Southern California Edison
RTRP A.15-04-013

DATA REQUEST SET A1504013 ED-SCE-04

Question ALT-1-001:

Figure 2: Wineville – Limonite Underground

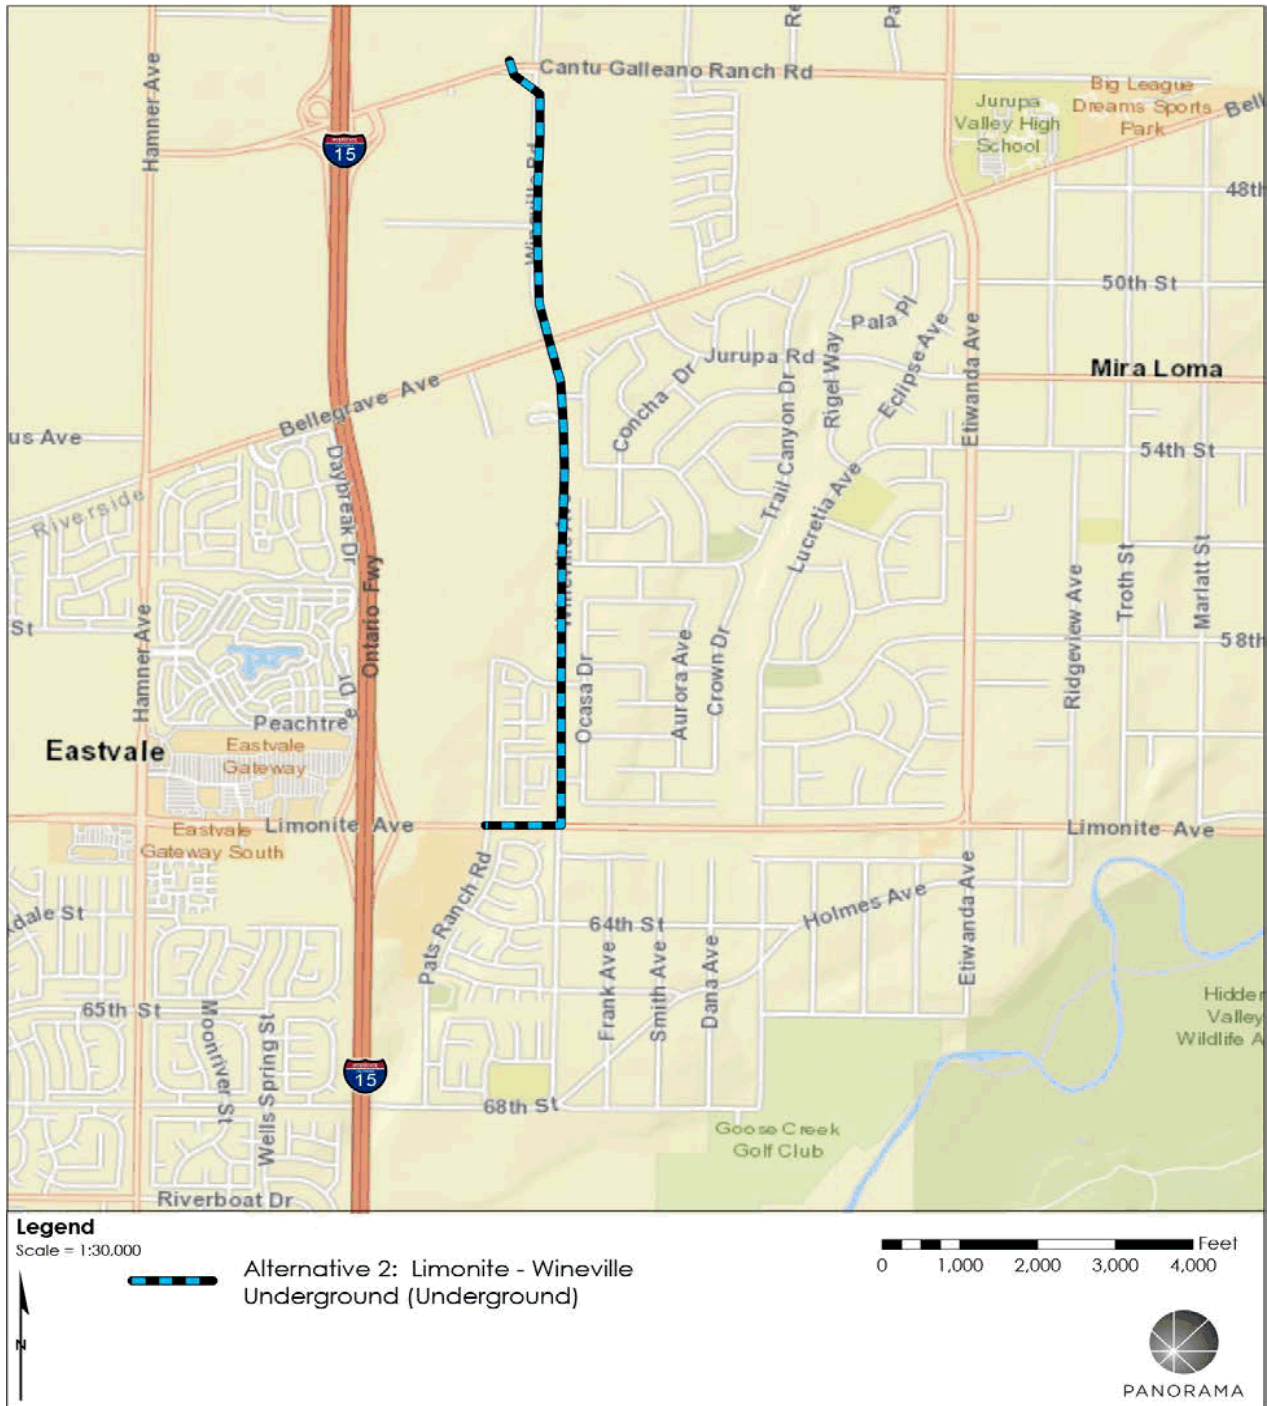
Alternative 2: Wineville - Limonite Underground (see Figure 3). The alternative would transition to an underground position adjacent to the tie-in to Mira Loma – Vista 230 kV #1 Line. The transmission lines would travel south under Wineville Road to Limonite Avenue. The transmission lines would turn west at Limonite Avenue and remain underground within Limonite Avenue to Pats Ranch Road.

The information requested is provided in SCE's responses to ED-SCE-04, Question No.Alt-1-001 pertaining to "Alternative 1: Bellegrave - Pats Ranch Road Underground."

Figure 3: Riser Pole Relocation and Wineville - Landon Underground

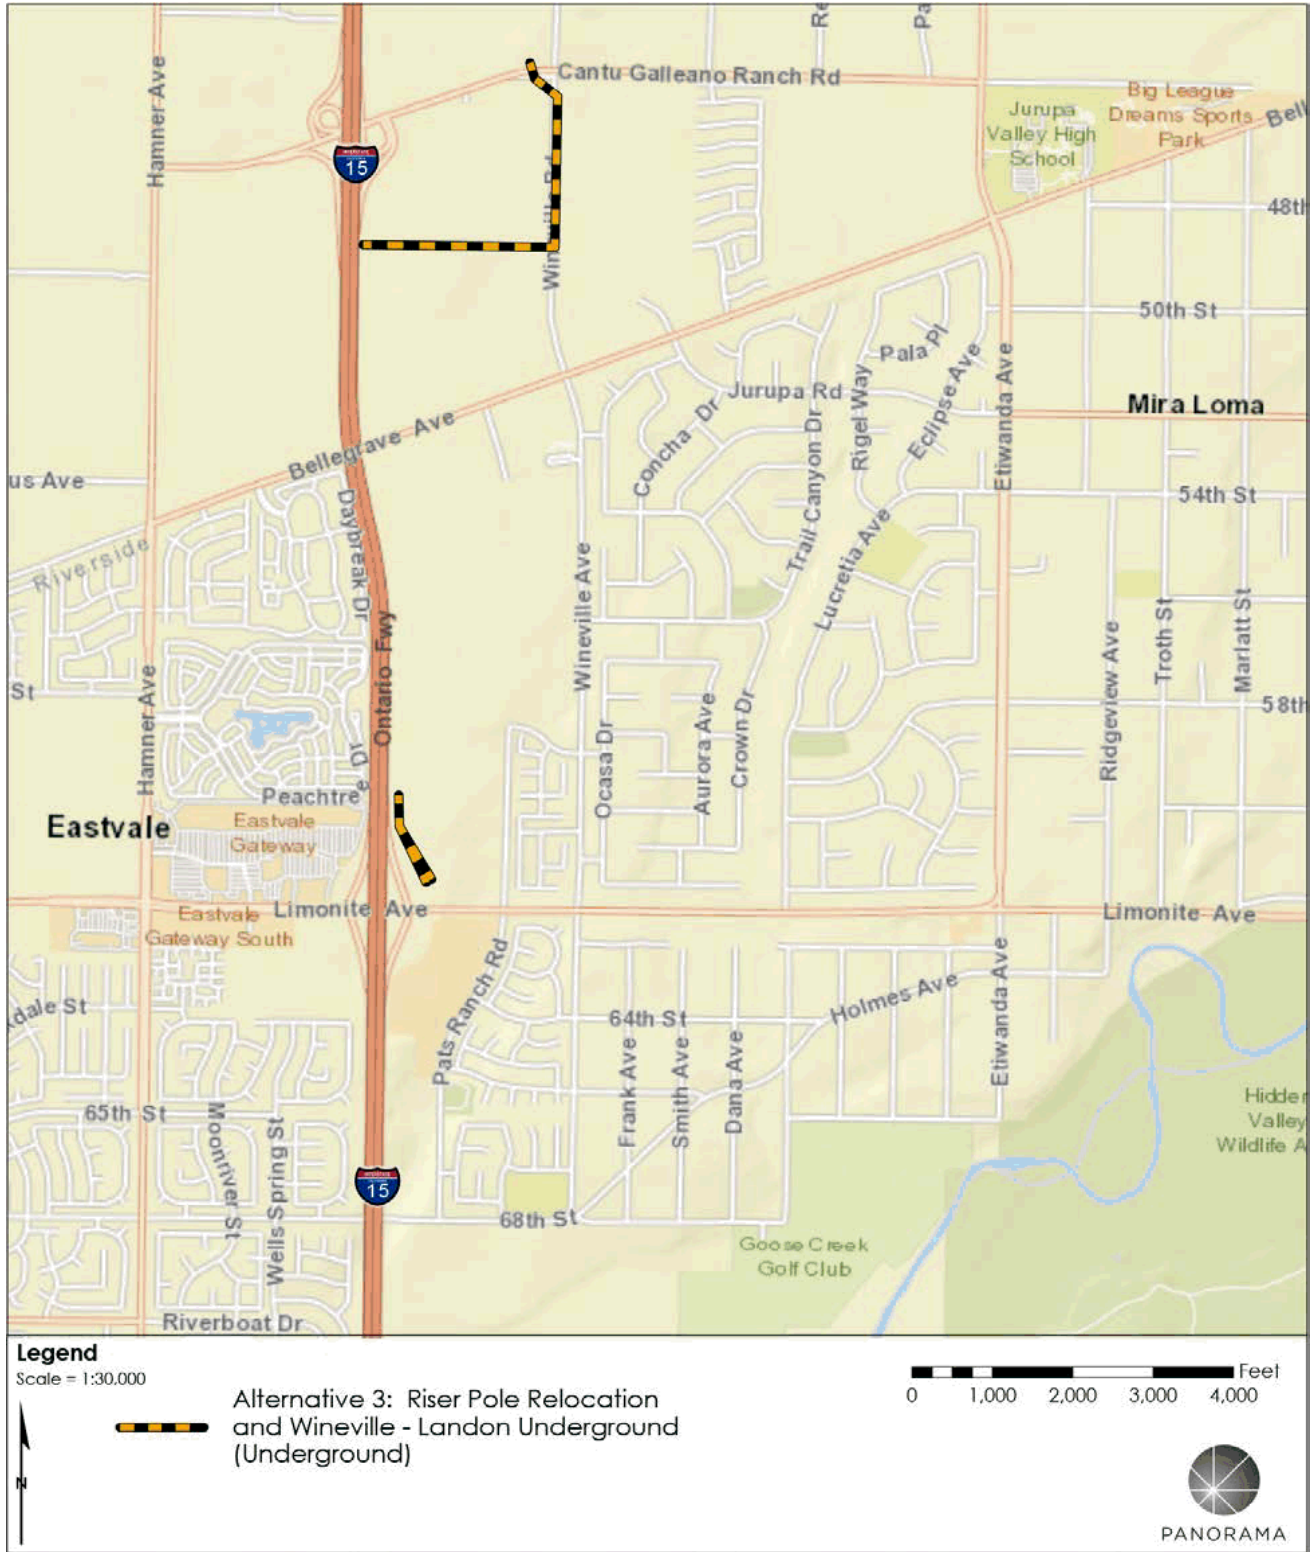
Alternative 3: Riser Pole Relocation and Wineville - Landon Underground (see Figure 4). The alternative would transition to an underground position adjacent to the tie-in to Mira Loma – Vista 230 kV #1 Line. The transmission lines would travel south under Wineville Avenue to Landon Drive. The lines would head west under Landon Drive. Just west of the terminus of Landon Drive the lines would transition to overhead. The transmission lines would follow the location of the revised project overhead lines adjacent to the I-15 freeway. Near Limonite Avenue, the riser pole would be relocated approximately 0.25 mile north-northwest of the proposed position and within the revised project alignment. The underground transmission line would follow the revised project alignment underground from the relocated riser pole.

The information requested is provided in SCE's responses to ED-SCE-04, Question No.Alt-1-001 pertaining to

"Alternative 1: Bellegrave - Pats Ranch Road Underground."
